### Staff Report to the Technical Review Committee December 2, 2014

### SUB2014-00065 Item # S2

Applicant is requesting a replat of a commercial lot to replat the Royal Pacific Resort site ahead of future development west of the subject site.

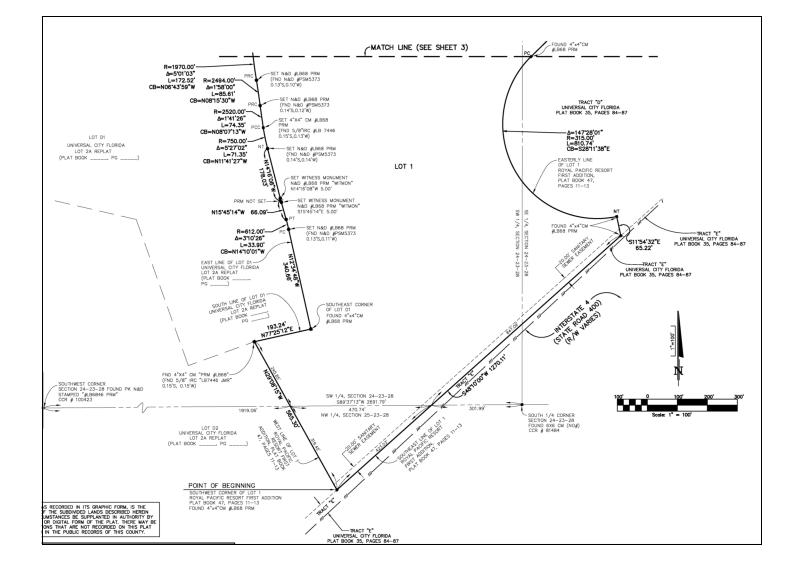
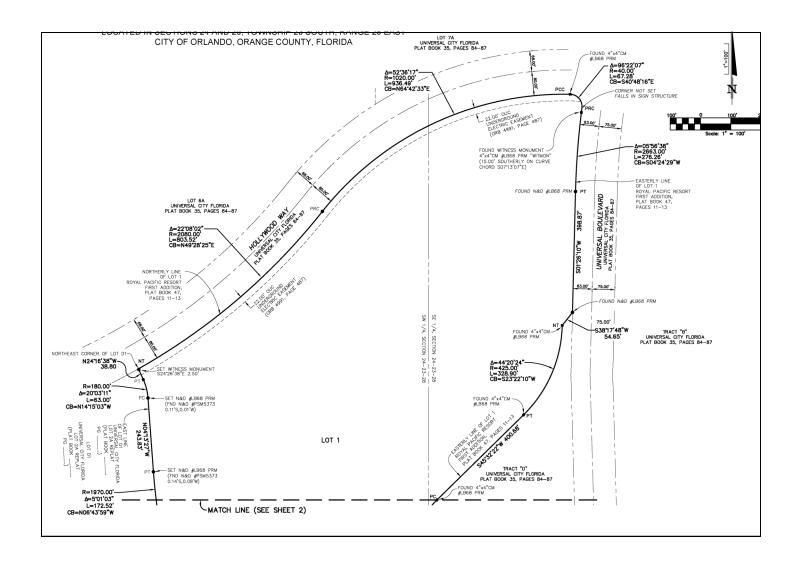
1. A sewer easement shown on the City's GIS database traversing this property is not depicted on the Plat.

1. Provided the dedication and qualification statement are properly executed, as well as the blank plat book and pages in the subtitle and on the plat are filled-in, this plat is satisfactory as to form and legality. Additionally, the dedication shows Universal City Development as a Delaware LP, whereas the certificate of title shows it as a Florida LP. This must be corrected.
